CONTRACT CHANGE ORDER No. 170
SHEET ___ OF ___

ROADWAY LEVEL EASTBOUND
LIGHTING AND ELECTRICAL SYSTEMS

ROADWAY LIGHTING POLE LOCATION PLAN-SHEET 42
SKYWAY STRUCTURES
NO SCALE

E-61

EE-42

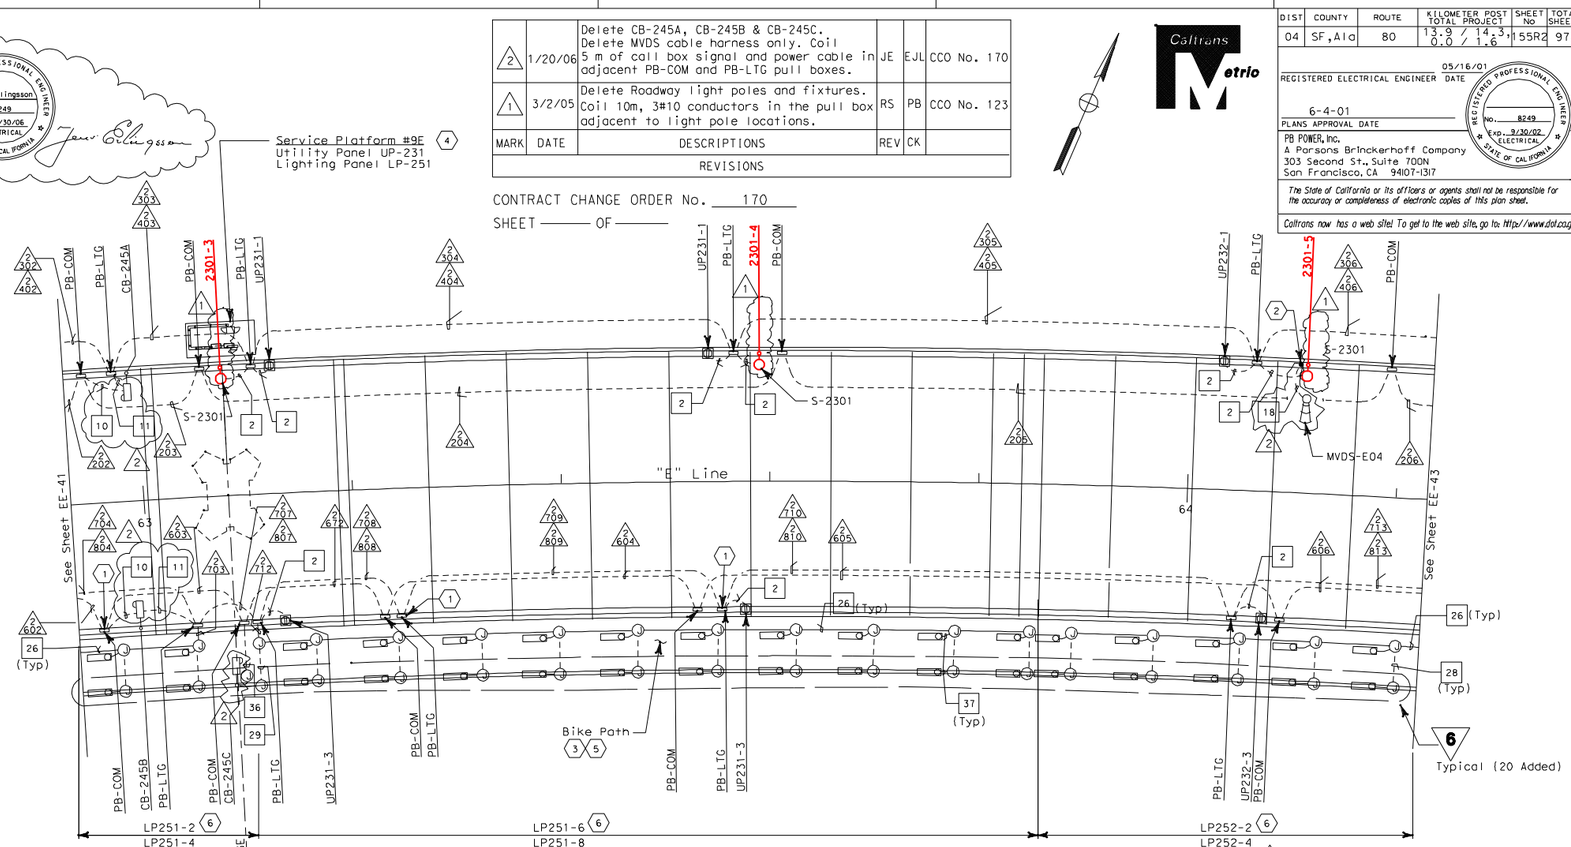
MARK	DATE	DESCRIPTIONS	REV	CK	
2	1/20/06	Delete CB-245A, CB-245B & CB-245C. Delete MVDS cable harness only. Coil 5 m of call box signal and power cable in adjacent PB-COM and PB-LTG pull boxes.	JE	EJL	CCO No. 170
1	3/2/05	Delete Roadway light poles and fixtures. Coil 10m, 3#10 conductors in the pull box adjacent to light pole locations.	RS	PB	CCO No. 123
